# PRODUCT INFORMATION

PTO PI1510.1\_GB

## „Z“ sliding ring for optional ST/STC/SD/SC and PG guard mounting

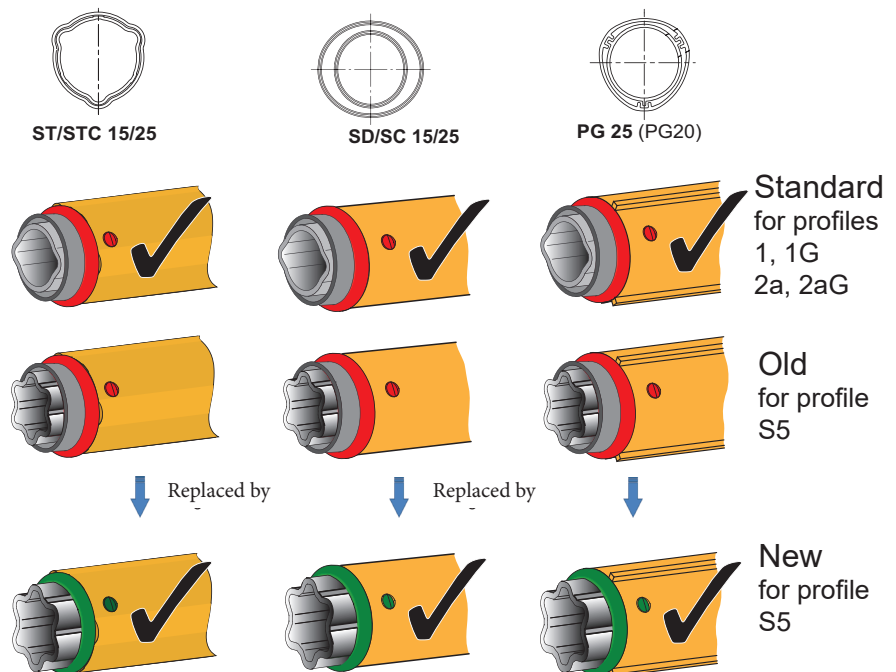
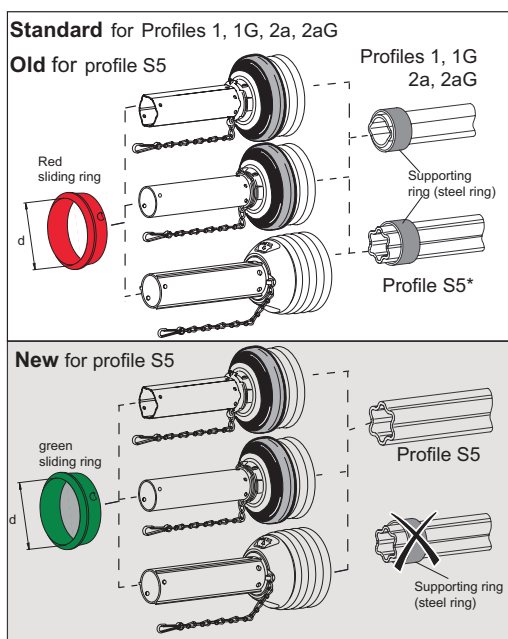
The „Z“ sliding rings come in two colours (red/green) for different profile tube versions. An additional supporting ring on the profile tube is required for all red „Z“ sliding rings, for profiles 1, 1G, 2a, 2aG and S5. Specifically for the S5 profile tube, the profile had to be partially turned down to 57.7 mm for mounting the supporting ring.

The new green „Z“ sliding rings now rest directly on the S5 profile tube. The supporting ring and turning-down of the profile tubes are no longer necessary.
